REMARKS

App'n. No. 10/689.885 filed October 21, 2003

Amendment and Response filed February 23, 2005 in Response to Office Action of December 21, 2004

FIG. 3a

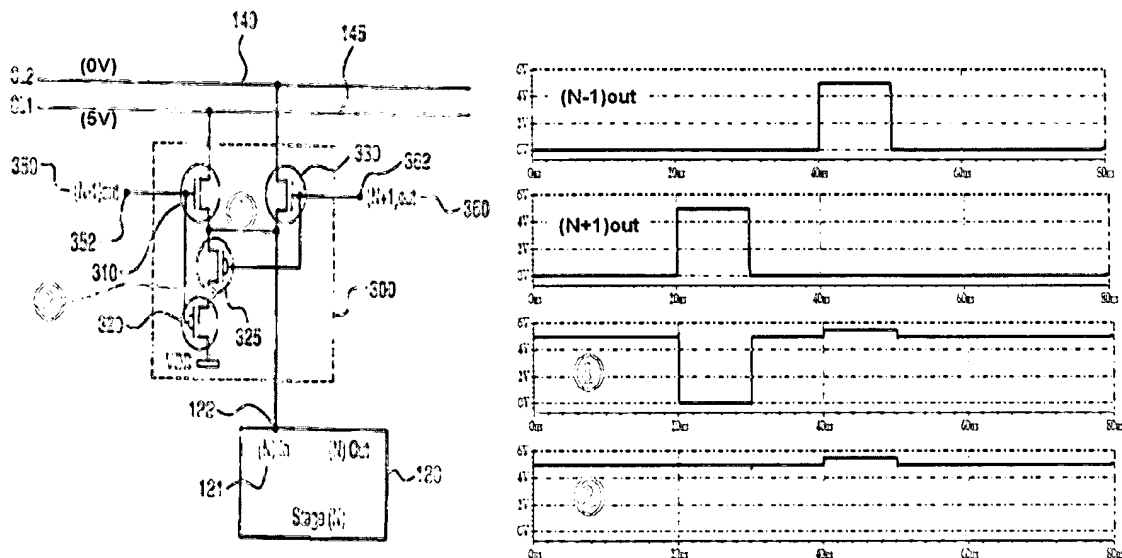
The examiner has objected to the specification as failing to provide proper antecedent basis for the claimed subject matter. Specifically the examiner states "Claims 1 and 16 recite terminal connections for the first through fourth transistors that are specific to the embodiment shown in Figure 4a; however, dependent claims, such as 3-7 and 19-23, recite limitations that are drawn to Figure 3a."

"the present claims also appear to describe structures with the same power supply connected to both the drain and source terminals of the recited transistors. More particularly, Figure 3a depicts the third power supply as being equal to V_{dd} so, for embodiments corresponding to Figure 3a, the circuit would not operate, seemingly, if the transistors having their drain source path connected to V_{dd} on one side also had the same path connected to V_{dd} on the

Response: The terminal connections for Figure 3a and Figure 4a are the same, as stated in specification paragraph 27, second sentence referring to Figure 4a: "In this second embodiment, shown as a NAND gate combinational logic circuit, the configuration is the same as that described with regard to Figure 3a and need not be repeated." The only difference between Figure 3a and Figure 4a is that "In this embodiment, p-type transistors replace the n-type transistors and n-type transistors replace the p-type transistors." (Specification paragraph 27). Further evidence that the terminal connections of Figure 3a and Figure 4a are the same, is evidenced by paragraph 28, sentence 3 referring to Figure 4a: "[S]ource terminals of the p-type transistor 410 and transistor 430 are electrically connected to control line CL₁ 145 and CL₂ 140 respectively." Similarly Paragraph 21, referring to Figure 3a states: "Source terminals of n-type transistor 310 and transistor 330 are electrically connected to control line CL₁ 145 and CL₂ 140 respectively."

Thus, the terminal connections in Figure 3a and Figure 4a are the same, only the types of transistors are different in each figure.

Response: At no time are all transistor drain/source paths connected at both ends to the same voltage. Control lines CL_1 145 and CL_1 140 are typically set in opposite states as described in the specification. See paragraph 21 "In the present invention CL_1 145 and CL_2 140 are set to different voltage levels . . . "; paragraph 22 "control line CL_1 145 is set to a low voltage, V_{ss} , and control line CL_2 is set to a high voltage, V_{dd} "; paragraph 25 "control line CL_1 145 is set to a high voltage, V_{dd} , and control line CL_2 140 is set to a low voltage, V_{ss} "; paragraph 29 "in this case, control line CL_1 145 is set to a high voltage, V_{dd} , and control line CL_2 140 set to a low voltage, V_{ss} "; and paragraph 31 "In this case, control line CL_1 145 is set to a low voltage, V_{ss} , and control line CL_2 140 is set to a high voltage, V_{dd} ." Thus, there is never a case where all transistors have the same voltage applied to both source and drain sides.

Fig. 3a, Case CL₁ = Vss, CL₂ = Vdd

Transistor	n - 1 = 0 n + 1 = 0	n - 1 = 1 n + 1 = 0	n - 1 = 0 n + 1 = 1
	Fig. 3b, ¶ 22	Fig. 3b, ¶ 23	Fig. 3b, ¶ 23
320	on	off	on
325	on	on	off
310	off	on	off
330	off	off	off
voltage at 122	Vdd	Vss	Vdd
path to 122	Vdd via FET 320 and FET 325	CL ₁ (Vss) via FET 310	Vdd via FET 330 drain forced high by gate/drain capacitance when N+1 goes high

Fig. 3a, Case CL₁ = Vdd, CL₂ = 0

Transistor	n - 1 = 0 n + 1 = 0	n - 1 = 1 n + 1 = 0	n - 1 = 0 n + 1 = 1
	Fig. 3c, ¶ 25	Fig. 3c	Fig. 3c, ¶ 26
320	on	off	on
325	on	on	off
310	off	off	off
330	off	off	on
voltage at 122	Vdd	Vdd	Vss
path to 122	Vdd via FET 320 and FET 325	Vdd level by FET 310 drain forced high by gate/drain capacitance when n-1 goes high	CL ₂ (Vss) via FET 330

Finally, the applicant includes here two SPICE circuit simulations to demonstrate that the circuits do function in practice as described in the specification. The first shows the circuit output (node 1) for Figure 3a where CL_1 is high and CL_2 is low, i.e. Figure 3c. The second chart shows the circuit output for Figure 4a where CL_1 is low and CL_2 is high, i.e. Figure 4c.

FIG. 4a

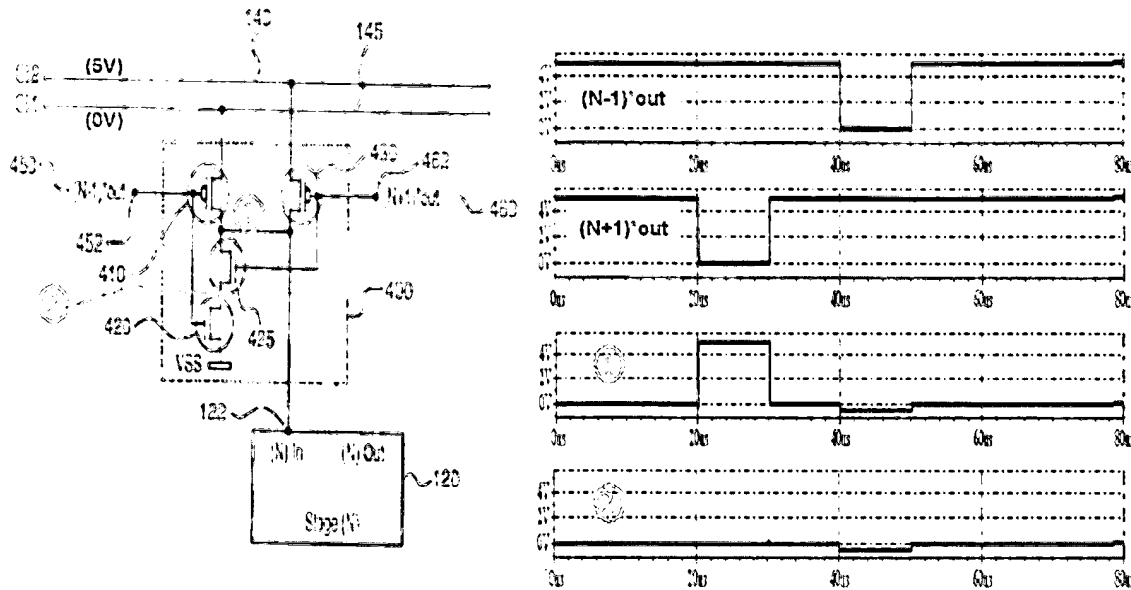
other side. Likewise, Figure 4a depicts an embodiment wherein the third power supply is equal to V_{ss} so, similarly, the same problem exists in terms of support for those embodiments reciting source/drain paths of transistors with both ends connected to the same power supplies. The specification does not support such hybrid embodiments nor does it disclose how it would function."

Further, the fact that transistor string 410, 425 and 420 (or 310, 325 and 320) might have the same voltage at the extreme ends of the string, does not preclude the transistors from functioning, since not all transistors in the string need to be on to have the proper voltage appear at the output, 122. For example, for the circuit depicted in Figure 4a, when CL_1 145 is at V_{ss} and CL_2 140 is at V_{dd} (i.e. transistor string 410, 425 and 420 connected at both ends to V_{ss}), when $(n-1)^*$ is high and $(n+1)^*$ is high, transistors 420 and 425 are on and the path from V_{ss} to output terminal 122 is complete

from Vss. With the same CL₁, CL₂ voltages when (N-1)* transitions low, the drain of transistor 410 is forced low by the gate/drain capacitance of transistor 410 because that capacitance was previously charged to 5V. That charge is sufficient to force terminal 122 low.

Fig. 4a, Case $CL_1 = V_{dd}$, $CL_2 = V_{ss}$

Transistor	$(n-1)^* = 1$ $(n+1)^* = 1$	$(n-1)^* = 1$ $(n+1)^* = 0$	$(n-1)^* = 0$ $(n+1)^* = 1$
	Fig. 4b, ¶ 29	Fig. 4b	Fig. 4b, ¶ 30
410	off	off	on
425	on	off	on*
420	on	on	off
430	off	off	off
voltage at 122	Vss	Vss	Vdd
path to 122	Vss via FET 420 and FET 425	Vss level by FET 430 source being forced low by gate/source capacitance when $(n+1)^*$ goes low	CL_1 (Vdd) via FET 410. Note FET 425 is on because its source is at Vss due to drain of FET 420 being forced low by drain/source capacitance when $(n-1)^*$ goes low.

Fig. 4a, Case $CL_1 = V_{ss}$, $CL_2 = V_{dd}$

Transistor	$(n-1)^* = 1$ $(n+1)^* = 1$	$(n-1)^* = 1$ $(n+1)^* = 0$	$(n-1)^* = 0$ $(n+1)^* = 1$
	Fig. 4c, ¶ 32	Fig. 4c, ¶ 31	Fig. 4c, ¶ 33
410	off	off	off
425	on	off	on*
420	on	on	off
430	off	on	off
voltage at 122	Vss	Vdd	Vss
path to 122	Vss via FET 420 and FET 425	CL_2 (Vdd) via FET 430	Vss level by FET 410 drain being forced low by gate/drain capacitance when $(n-1)^*$ goes low. Note, FET 425 is on because its source is at Vss due to drain of FET 420 being forced low by its gate/drain capacitance when $(n-1)^*$ goes low.
